Access Compliance Report

Public Rights-of-Way

Intersection ID: N/A	Main Street: ARDREY_KELL_DR	Cross Street: PRINCETON_VILLAGE_DR	Location: SW
ADA ID: 5D9A01161E20	Ramp Type: BlendTrans2	Initial Pass/Fail: Pass	Overall Compliance: No
		Severity Score: 10

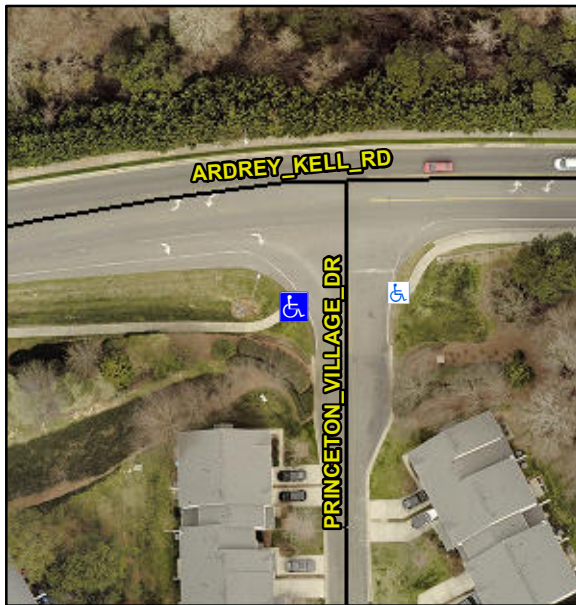
NO CURB

R305, R304.5.3

Possible Solutions:

**Install Detectable Warning System.
Remove & Replace Gutter.**
